STAFF REPORT
COMMUNITY DEVELOPMENT DEPARTMENT

HEARING DATE: 12/22/2020
 TO: Mayor & City Council
 FROM: Alan Tiefenbach
 208-489-0573
 SUBJECT: H-2020-0093
 Oakwind Estates Subdivision – PP and MDA
 LOCATION: Northeast Corner of N. McDermott Road and W. McMillan Road

F. Townhouse Parking Plan

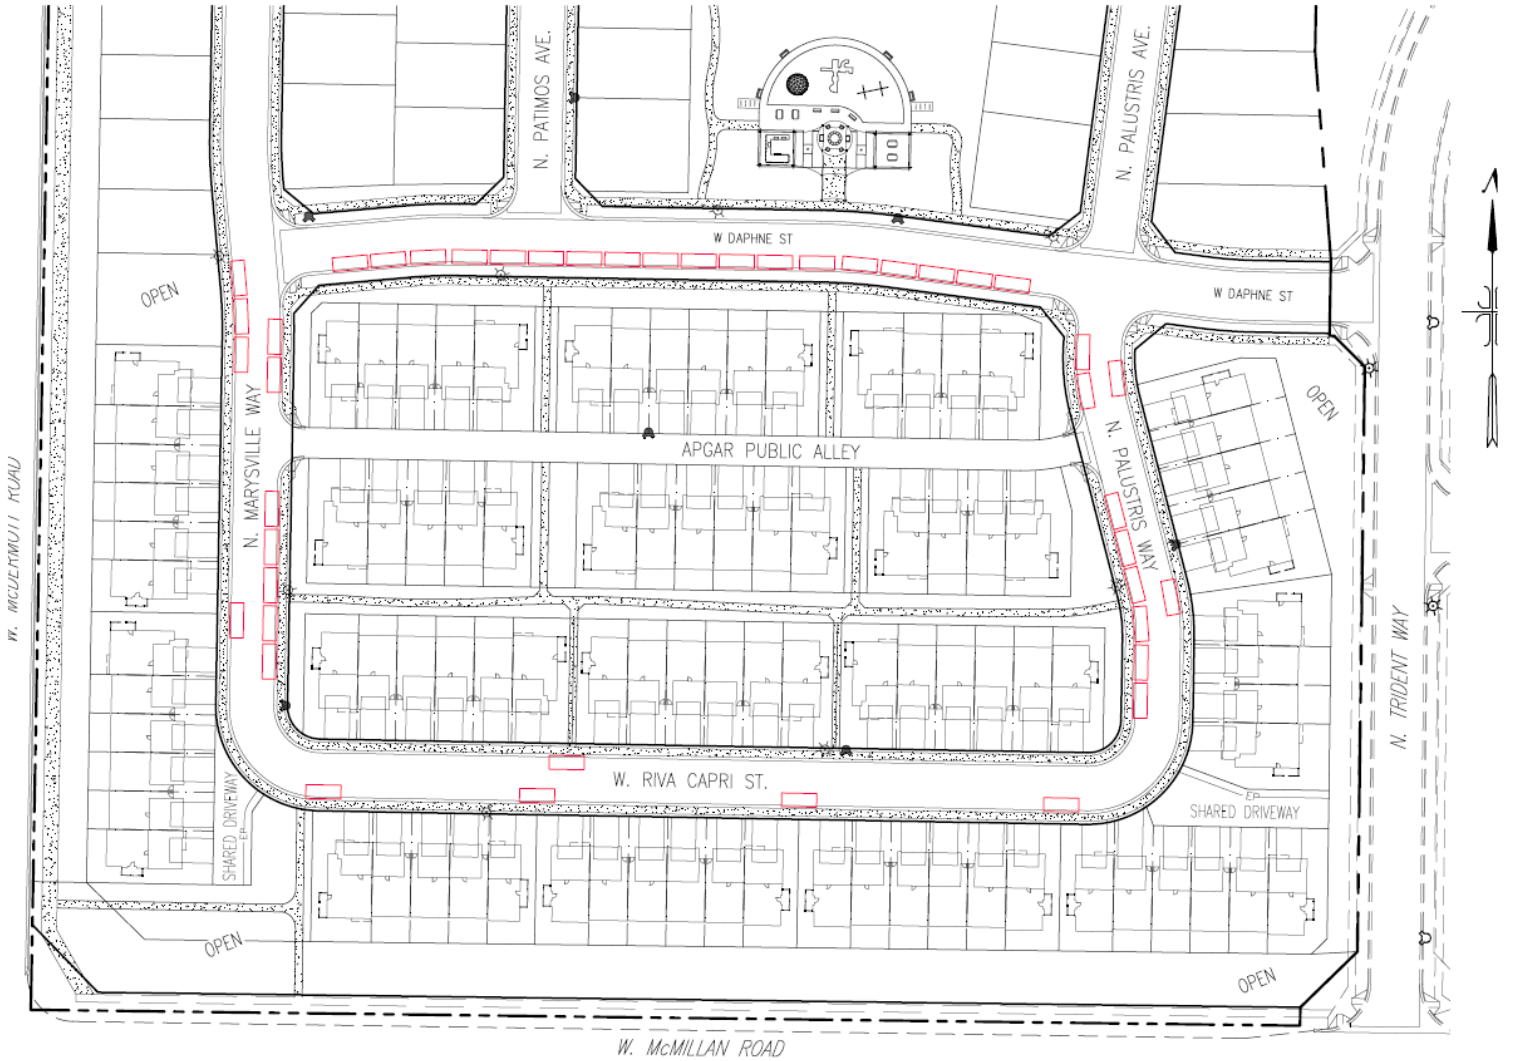
The applicant has provided a parking exhibit for the single family attached portion of the project (southern portion). The parking plan provides a 33' local street section which allows for additional on-street parking. It is important to note this on-street parking does not count toward meeting minimum requirements. ACHD and Meridian Fire have both reviewed the plan and have not expressed concerns.
